**AOS SPACE DATA
LINK PROTOCOL**

CCSDS 732.0-P-4.2

PROPOSED PINK SHEETS
August 2024

Figure 4-2: Transfer Frame Primary Header

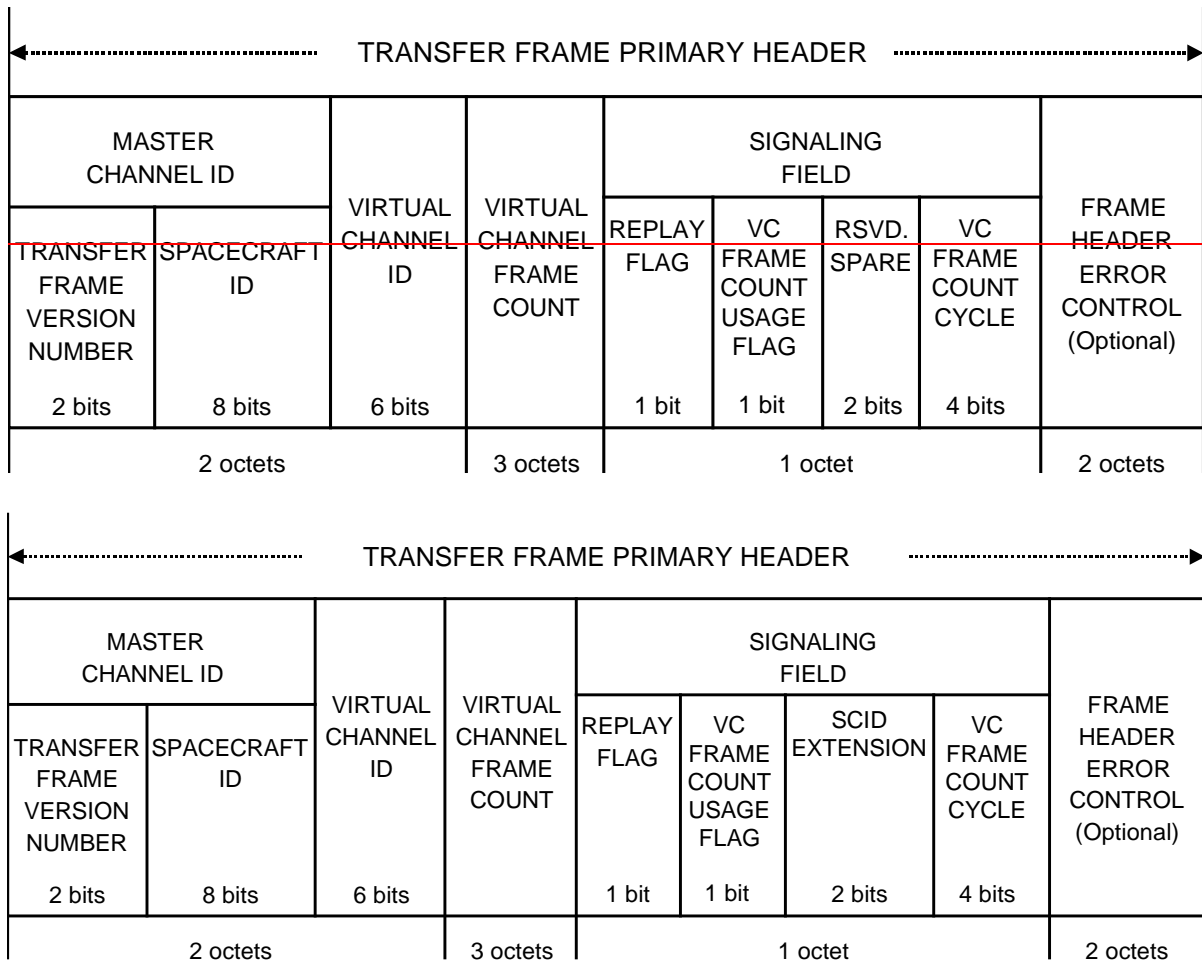
~~Bits 2–9 of the Transfer Frame Primary Header shall contain the Spacecraft Identifier (SCID).~~

4.1.2.2.3.1 The length of the Spacecraft Identifier (SCID) depends upon the value of the 2-bit SCID Extension field (defined in 4.1.2.5.4). The SCID can be either 8 or 10 bits in length.

4.1.2.2.3.2 If the SCID Extension field is set to ‘00’ then bits 2-9 of the Transfer Frame Primary Header contain the Spacecraft Identifier, defining the 8-bit SCID.

4.1.2.2.3.3 If the SCID Extension field is not set to ‘00’ then these two bits are to be interpreted as two additional high-order bits added at the beginning (i.e., the most left justified when drawing a figure) of the 8-bit SCID, defining the 10-bit SCID.

- a) Replay Flag (1 bit, mandatory);
- b) Virtual Channel (VC) Frame Count Cycle Use Flag (1 bit, mandatory);
- c) ~~Reserved Spares~~SCID Extension (2 bits, mandatory);
- d) Virtual Channel Frame Count Cycle (4 bits, mandatory).

4.1.2.5.4 ~~Reserved Spare~~ SCID Extension

4.1.2.5.4.1 Bits 42-43 of the Transfer Frame Primary Header shall contain the ~~reserved spare~~ SCID Extension.

NOTE – The SCID Extension provides a mechanism to extend the SCID from 8 bits to 10 bits, thereby increasing the number of spacecraft addressable by this protocol.

4.1.2.5.4.2 ~~This 2-bit field is reserved for future definition by CCSDS and shall be set to '00'. The interpretation of this field is defined in 4.1.2.2.3.~~
